**To:** Dianne Boisvert **Subject:** FW: 177 State Street

Subject: 177 State Street

I am connecting you with TJ Melvin at Millennium Engineering, Inc. We have a new minor site plan review application. There is a mixed use building going up in the town of Newbury and four of the parking spots for the new building are in Newburyport. The only review required under the NZO is that of minor site plan review based on the fewer than 10 parking spaces associated with a new Use. The parking is accessory to the primary Use that lies within the town of Newbury. Can you please take a look at the site plan and connect with TJ if needed. Please see the below link to the site

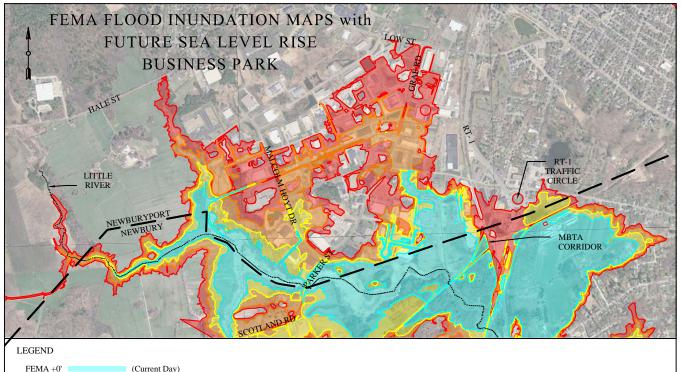
As a friendly gesture for the Applicant, the attached graphic shows what the Business Park will likely look like when you add sea level rise (SLR) to the current FEMA flood maps. The Applicant should consider putting the first floor elevation 6' or more above current FEMA flood elevation. These maps are based on our own internal review of international, national, and local flood model predictions for years up to 2100. The logic is that any new building built today will still be standing in year 2100 so it should be built so the first floor is higher than the future FEMA flood elevation (i.e. FEMA + SLR). It's all modeling and guesswork as to what those elevations will be. But anything higher than FEMA would be a wise thing to do. This area is tidally impacted.
